# UNITED STATES PATENT AND TRADEMARK OFFICE

APPLICATION NO.	FILING DATE	FIRST NAMED INVENTOR	ATTORNEY DOCKET NO.	CONFIRMATION NO.
10/591,181	08/30/2006	Hirofumi Nozawa	293599US3PCT	7758
22850	7590	12/22/2008		
OBLON, SPIVAK, MCCLELLAND MAIER & NEUSTADT, P.C. 1940 DUKE STREET ALEXANDRIA, VA 22314				
EXAMINER				
IRVIN, THOMAS W				
ART UNIT		PAPER NUMBER		
3657				
NOTIFICATION DATE		DELIVERY MODE		
12/22/2008		ELECTRONIC

### Office Action Summary

## **DETAILED ACTION**

**Fig. 4 (US 6,669,588)**

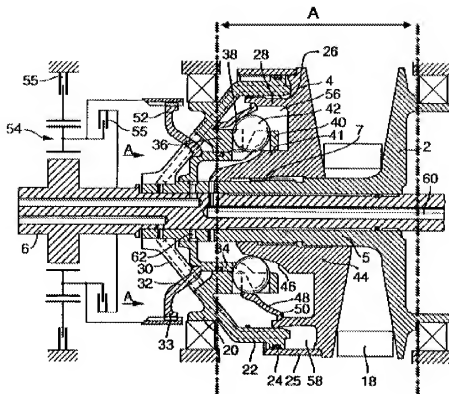
In Re claims 14 and 25, with reference to Fig. 4 shown above, Schmid discloses a belt type continuously variable transmission comprising: a pulley shaft (6) that is supported by a first and second bearing (depicted as blocks with X's) that are spaced apart axially; a supply oil passage (30,60,62) that supplies hydraulic fluid to a pulley hydraulic chamber (56,58) and includes a radial direction oil passage (60,62) that extends in the pulley shaft in a radial direction of the pulley shaft (see fig. 2); a movable sheave (4,44) that is attached to the pulley shaft; and a cylinder member (22,34) that is attached to the pulley shaft and faces the movable sheave, wherein the radial direction oil passage is formed in the pulley shaft outside of a portion of the pulley shaft that is between the bearings (A), and an outer peripheral surface of an inner cylindrical portion

of the movable sheave contacts and partially slides on an inner peripheral surface of a first cylindrical portion of the cylinder member (see annular sleeve (28)).

In Re claim 18, the pulley hydraulic chamber includes a first hydraulic chamber (58), and the first hydraulic chamber is limited at least in part by a back surface of the movable sheave (4,44) and the cylinder member which faces the movable sheave.

In Re claim 19, the pulley hydraulic chamber includes a second hydraulic chamber (56), and the second hydraulic chamber is limited at least in part by an end surface of the inner cylindrical portion of the movable sheave and the cylinder member.

In Re claims 20 and 23, the cylinder member includes a first and second radial direction portion and a first and second cylindrical portion (see sensing piston (34), seal support (20) and cylindrical region (22)).

In Re claim 21, see chamber (58), fixed annular element (25) and annular sleeve (28).

In Re claim 22, see chamber (56), annular sleeve (28), cylindrical region (22), and seal support (20).

In Response to applicant's arguments that the radial oil supply passages of Schmid are between the bearings, the examiner has included an annotated copy of Fig. 4 from Schmid with dashed lines clearly showing the portion (A) located between the bearings, which does not include any of the radial oil supply passages.

Additionally, the examiner suggests amending the claims to specifically recite that the bearings are located on opposite sides of the movable sheave, and that the portion of the shaft between the bearings includes a fixed sheave and the portion of the shaft supporting the movable sheave.
